# Regulatory Compliance Report

Redfern Place  
600-660 Elizabeth St, Redfern

Prepared for: **Bridge Housing**  
Date: **21 June 2024**  
Revision: **F**

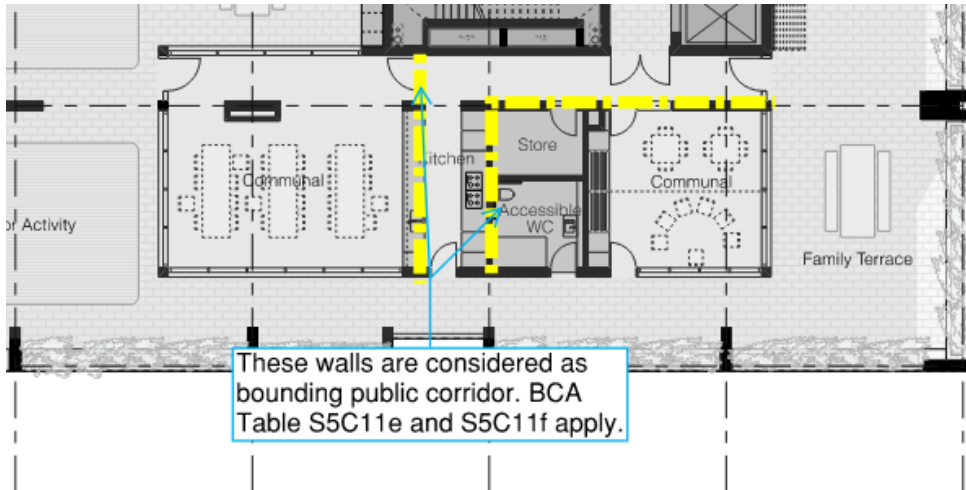
The residential corridors at S2 are generally considered to be open balcony, with the exception at Levels 11 to 13, where the south apartments are not located along an open balcony/ landing.

S3 - Level 5 & 6

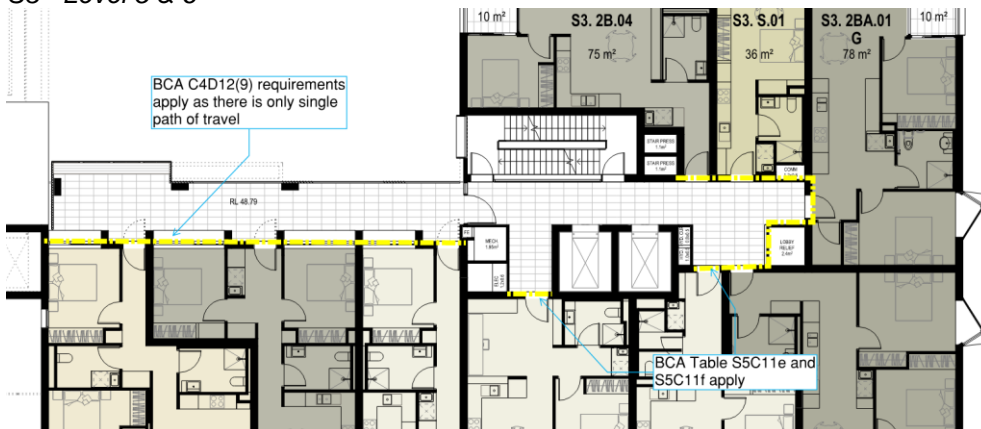
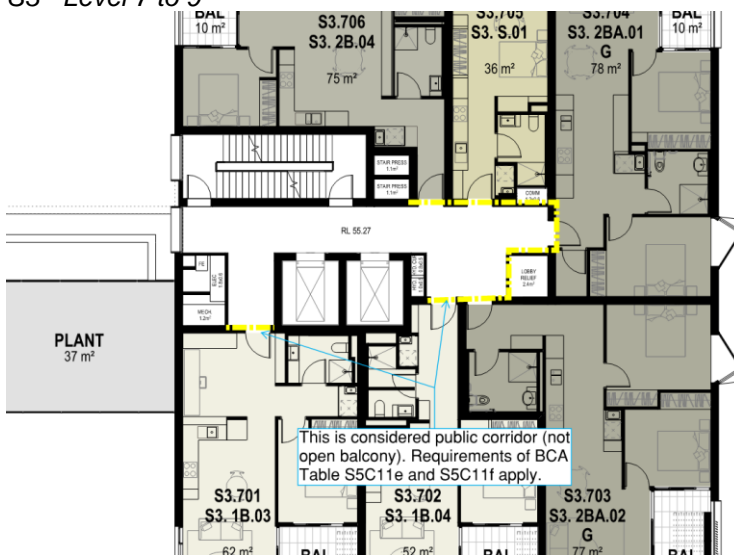
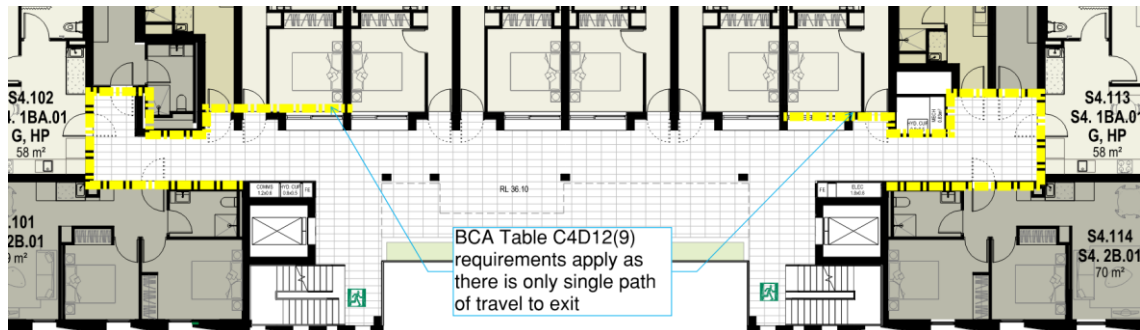
Similarly at S3, the residential corridors are generally considered to be open balcony between Ground to Level 4. However, at Level 5 to 6, requirements of C4D12(9) as the south apartments are provided with single path of travel only. At Levels 7 to 9, the corridor not considered as open balcony, and requirements of Table S5C11e and S5C11f apply.

- S1 east elevation

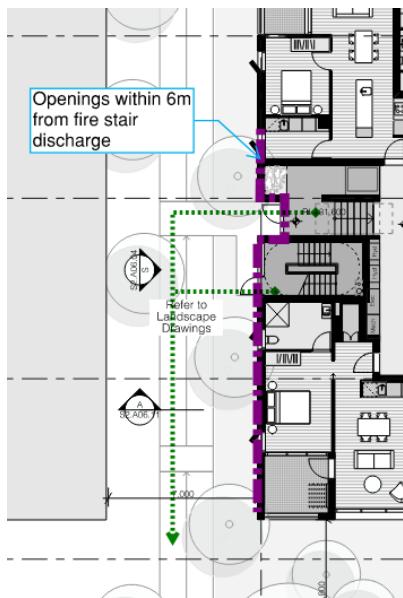
The following fire stairs discharge require passing through within 6m from the building:

Further review/ discussion is required at detailed design phase. Alternatively, where compliance with DTS provisions cannot be achieved, performance solution assessment is required.
